Access Compliance Report

Public Rights-of-Way

(Curb Ramps)

Intersection ID: 18326	Main Street: WOOD_LAWN_RD	Cross Street: PINEHURST_PL	Location: SW
ADA ID: 1FEF76BD45EA	Ramp Type: Perp	Initial Pass/Fail: Fail	Overall Compliance: No
		Severity Score: 37.5

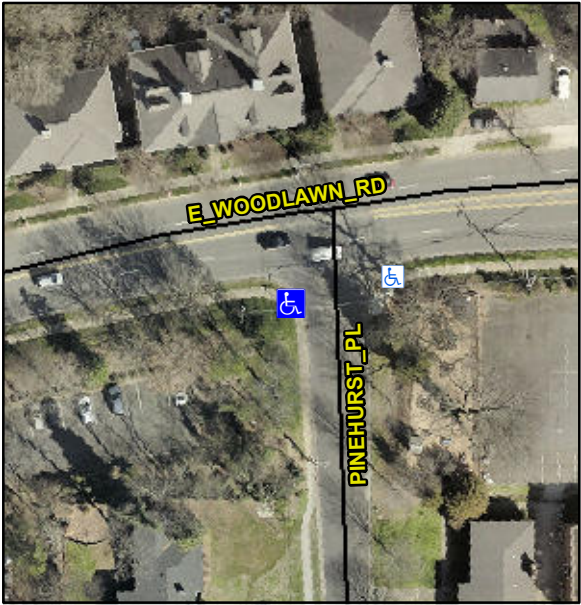
Codes/Mitigation Info/Possible Solution			Field Measurements/Component Compliance		
	Possible Solutions:		Compliance	Description	Data
	Remove & Replace Entire Ramp.		No	Ramp Length (in)	61.0
			Yes	Ramp Width (in)	48.0
			N/A	Flare Type LT	N/A
			N/A	Flare Slope LT (%)	N/A
			N/A	Flare Traversable LT?	N/A
			N/A	Landing Length (in)	N/A
			N/A	Landing Width (in)	N/A
			N/A	Landing Slope (%)	N/A
			N/A	Landing X Slope (%)	N/A
			N/A	Landing Curb? (Y/N)	N/A
			N/A	Shared Landing?	N/A
			N/A	Gutter Ponding?	N/A
			N/A	Gutter Lip Ht (in)	N/A
			No	Painted X Walk1?	N/A
				X Walk 1 Direction	To E
			N/A	X Walk 1 Width (in)	N/A
				X Walk 1 Slope (%)	6.3
				X Walk 1 X Slope (%)	5.7
			N/A	Ramp inside XWalk1?	N/A
<p>Surveyor Notes:</p> <p>N/A</p> <p>PROW/ADA:</p> <p>Not Found, R304.2.2, R304.5.3</p>			N/A	Road Slope (%)	N/A
			N/A	Road X Slope (%)	N/A
			N/A	Any Obstructions?	N/A
				Obstruction Type	
			N/A		N/A
			Yes	Surface Condition? (G/P)	Good
